## Planning and Land Use Committee Report

**To:** Planning and Land Use Committee **Date:** September 18, 2014  
**From:** Lucina Baryluk, Senior Process Planner  
**Subject:** **Official Community Plan Amendment, Rezoning Application #00446 and Development Permit Application #000365 for 2328 Richmond Road** - Application to change the Urban Place Designation within the *Official Community Plan* and to rezone the subject property to permit a 12-unit residential development

# Application for Official Community Plan Amendment, Rezoning & Development Permit

## 2328 Richmond Road

PROPOSED RICHMOND ROAD STREET VIEW

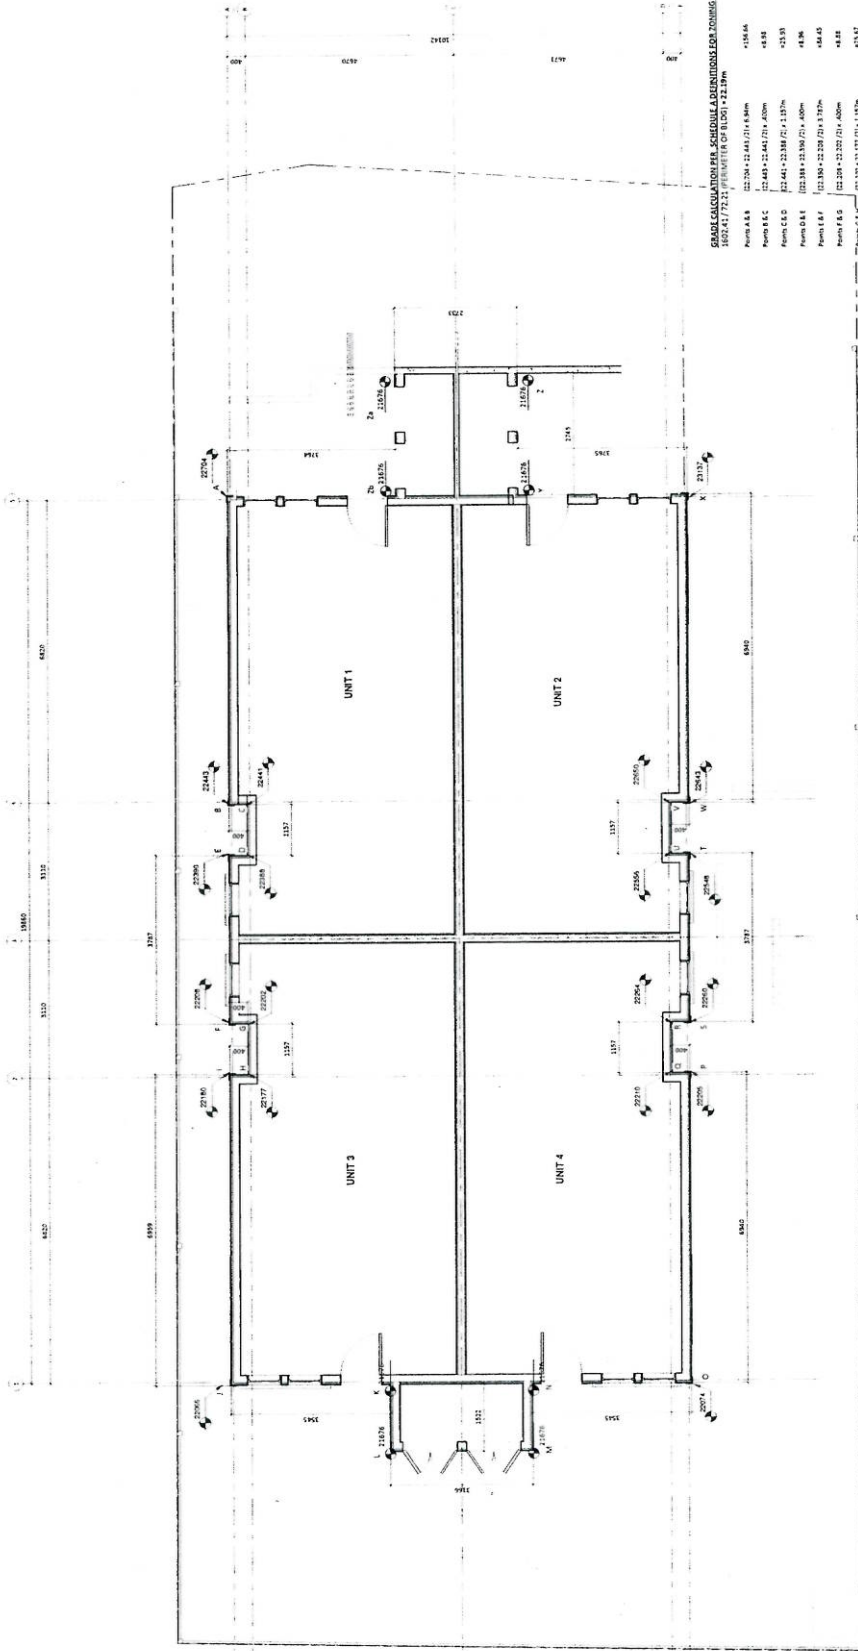
- 4. *Please provide the street elevation plans on a separate sheet, as the scale makes it difficult to assess.***

The street elevations – existing and proposed – have been provided on a separate sheet to facilitate assessment, and are included in our resubmission package.

Exterior Elevations

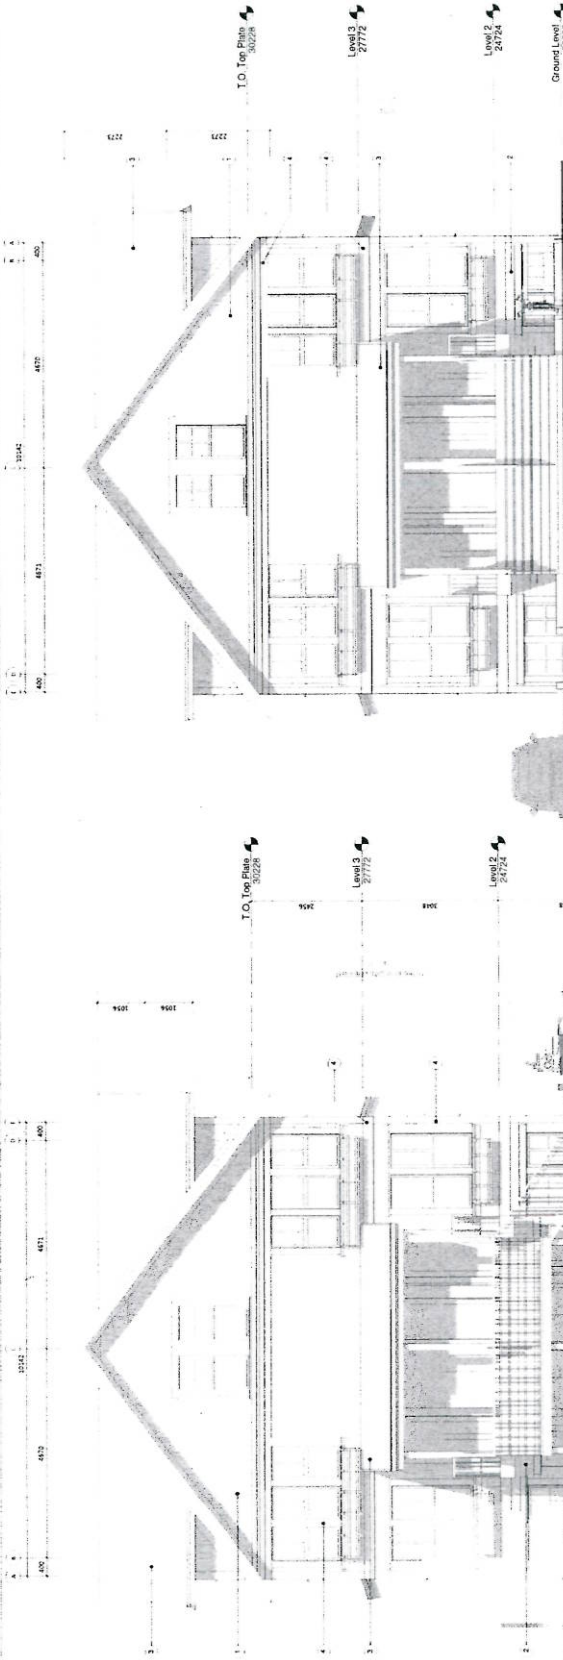
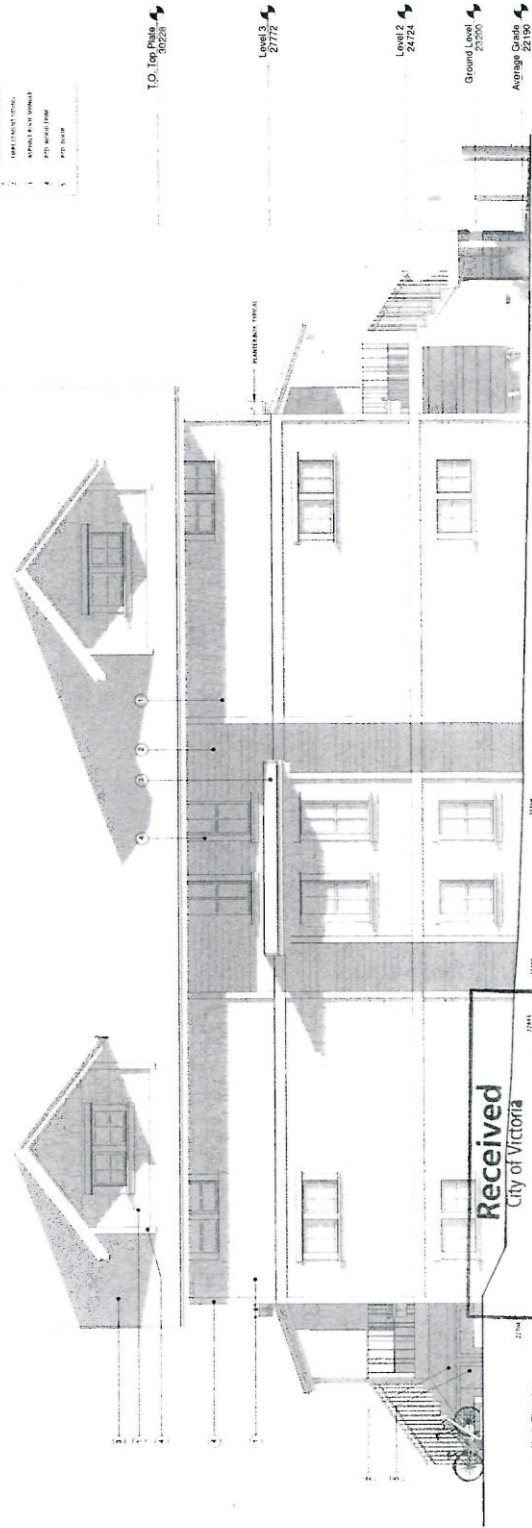
The plans for the second storey entrances on both the East and West elevations have been changed since the CALUC meeting in which the four entrances were shown as two on one side and two on the other whereas in the new plans the entrances are four doors side by side which do not appear as welcoming, or offer as much privacy, as the previous design. In the applicant's letter to City Council he states "the proposed density realizes a transitional residential type to the single family character to the west, thereby locating density along the perimeter of this established neighbourhood". While this type of density at arterials roads is generally buffered by several neighbourhood blocks in the core, our neighbourhood streets are all one-block long which tends to create increased density throughout our community.
